# North Lincolnshire Green Energy Park

9.25 Applicant's Responses to  
Deadline 5 submissions

PINS reference: EN010116

March 2023

## **APPENDIX A: APPENDIX A: ROUTES TO BE ADOPTED BY VEHICLES TRANSPORTING RDF**

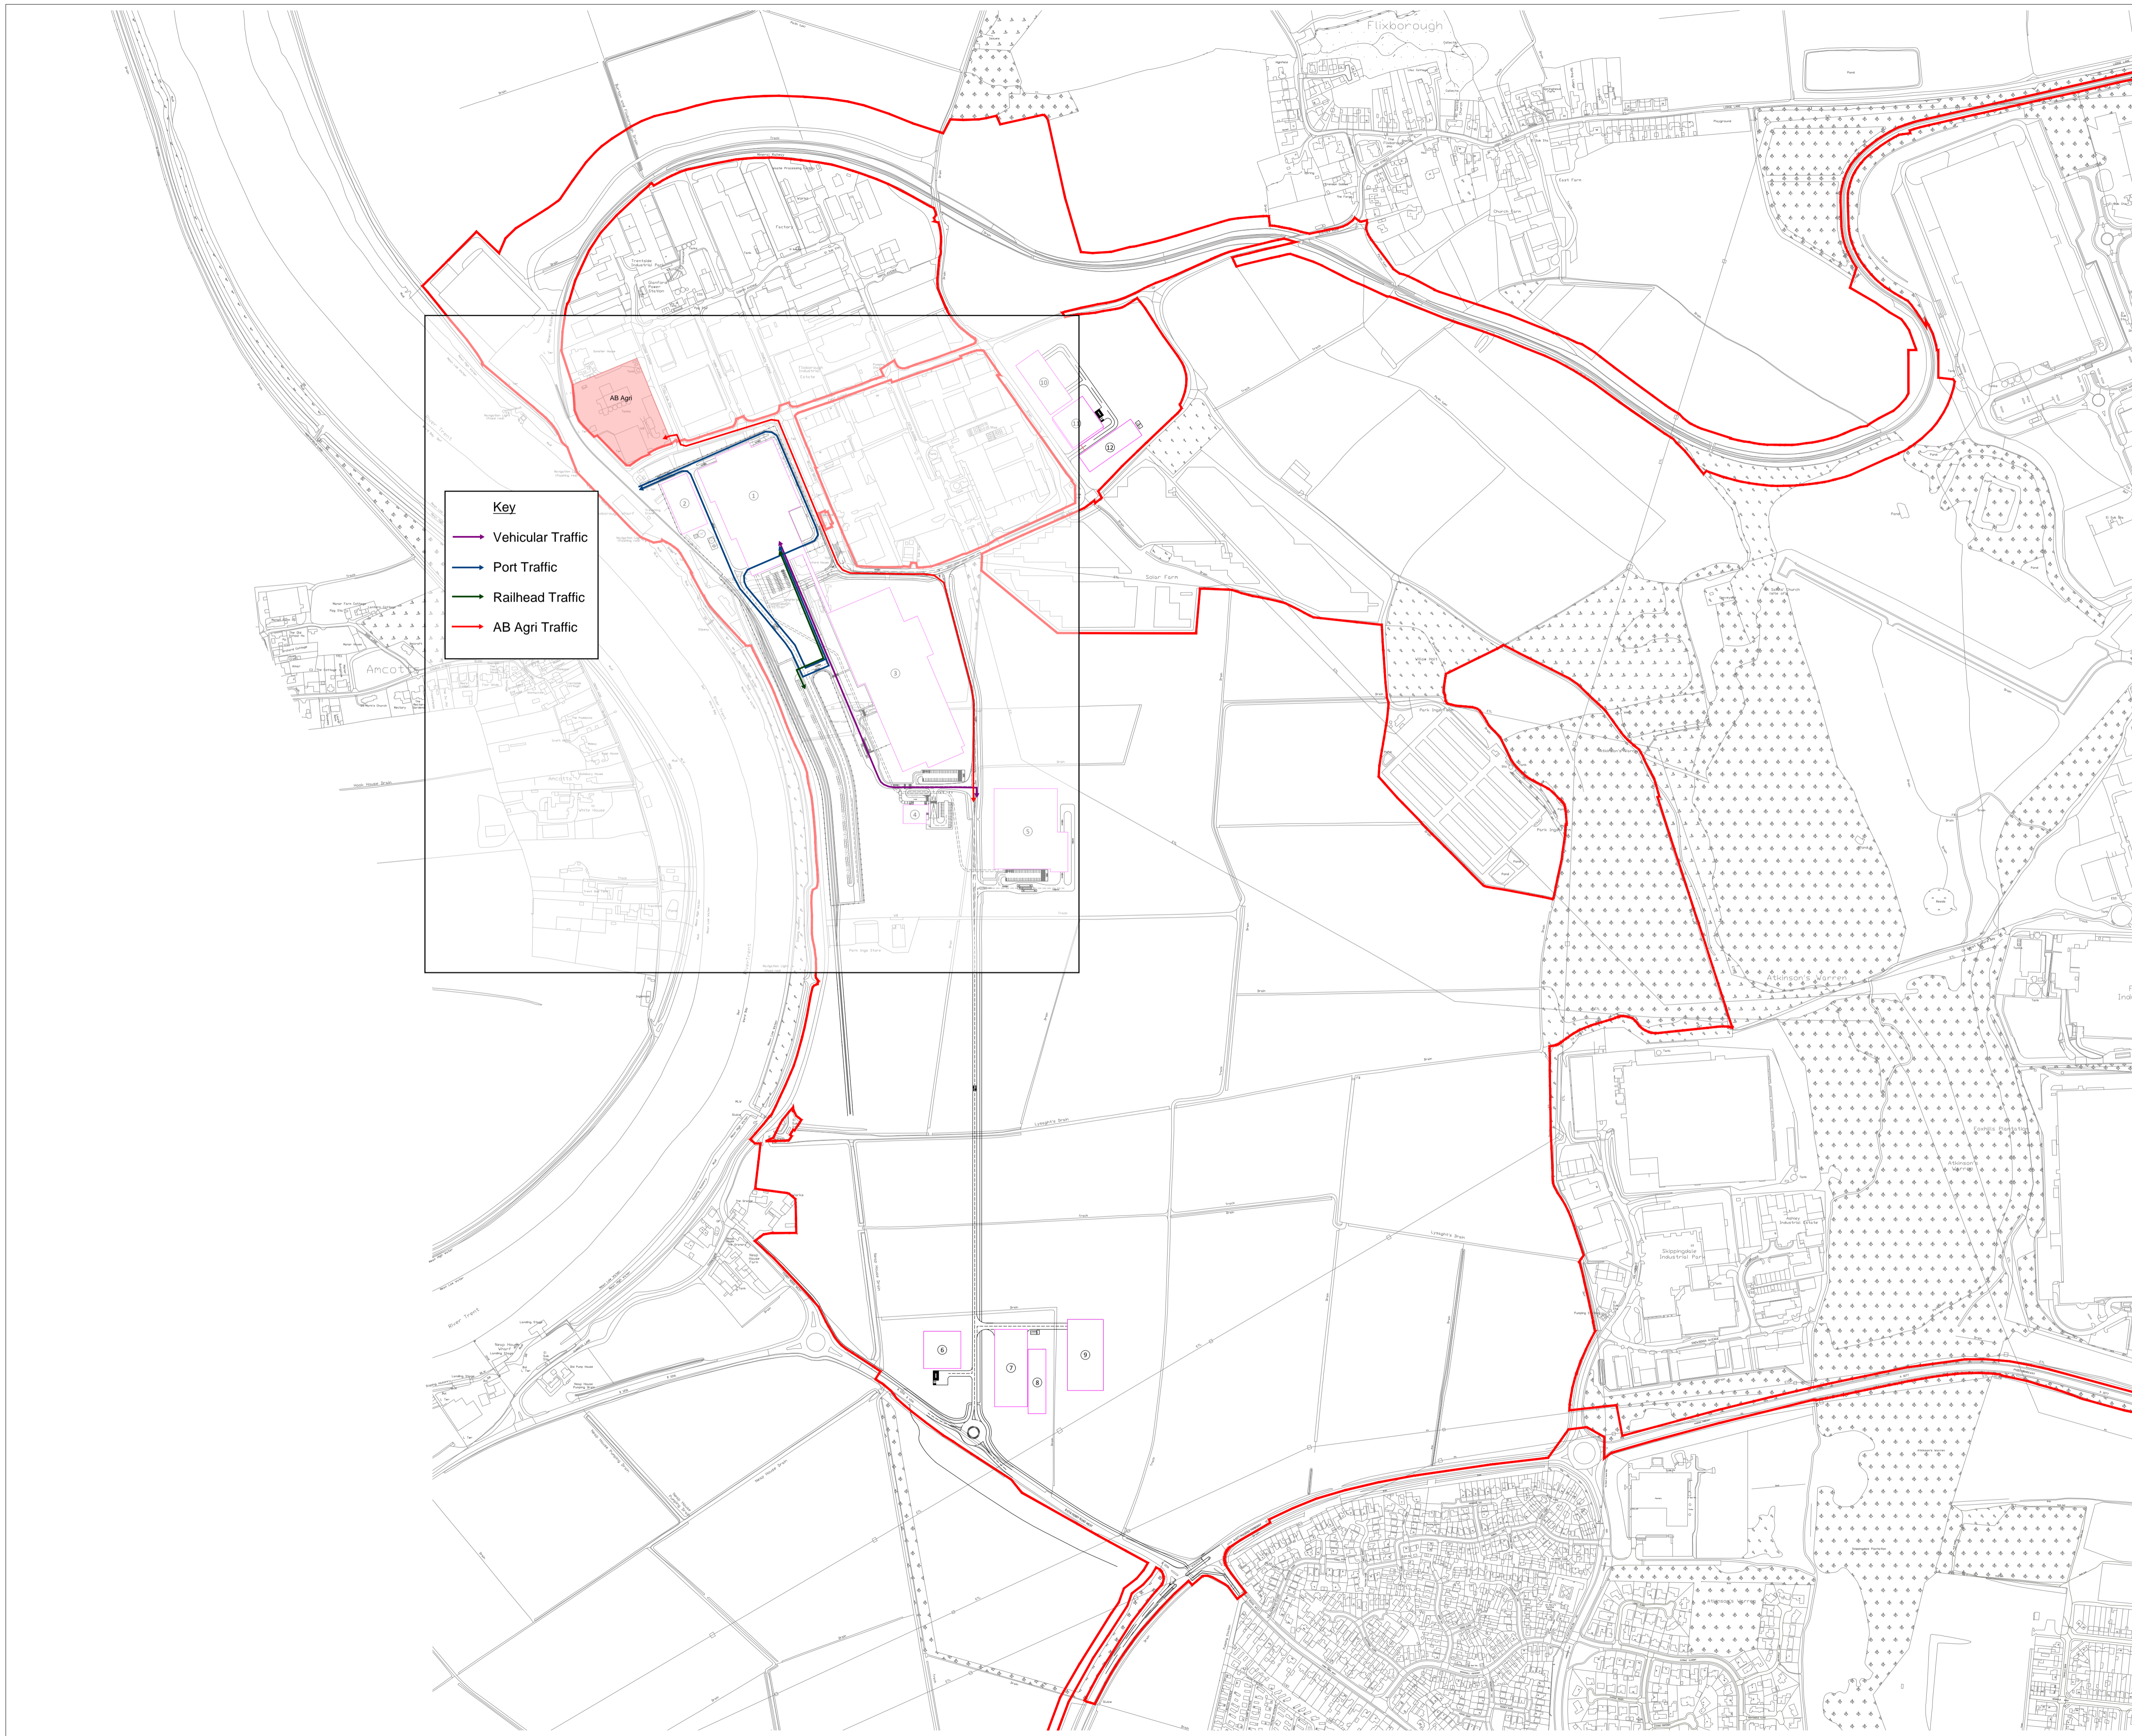
Matter raised by AB Agri	Applicant response in brief
	vehicles to use public roads will be those accessing the ERF via the new access road to the south.
A routing agreement that HGVs do not drive past ABN.	The Applicant has committed to no vehicles carrying RDF using First Avenue. This will be secured in the OEMP

3.30 At this stage it is the view of the Applicant that compliance with the RDF CoP, and the routing change, will minimise any risks to AB Agri involved in transporting RDF. The operation of the Project will be regulated by the terms of the Environmental Permit from the Environment Agency, specifically through a Pest Management Plan. It is anticipated that in addition to a Pest Management Plan, aspects of the delivery and handling of RDF set out in the RDF CoP will be covered by the terms of the permit where they take place within the permit 'installation boundary', thus becoming a legal compliance matter for the Applicant. Any operational environmental management requirements that fall outside the remit of the Environmental Permit, including the manner in which RDF is transported to the site, will be addressed by an Operational Environmental Management Plan (OEMP) (which will be approved by North Lincolnshire Council, with input from the Environment Agency) as secured by DCO Requirement 4. The OEMP will also incorporate relevant aspects of the RDF CoP as well as specifying the routes to be adopted by vehicles transporting RDF in the vicinity of the Project Site and AB Agri, see proposed plan at Appendix A.
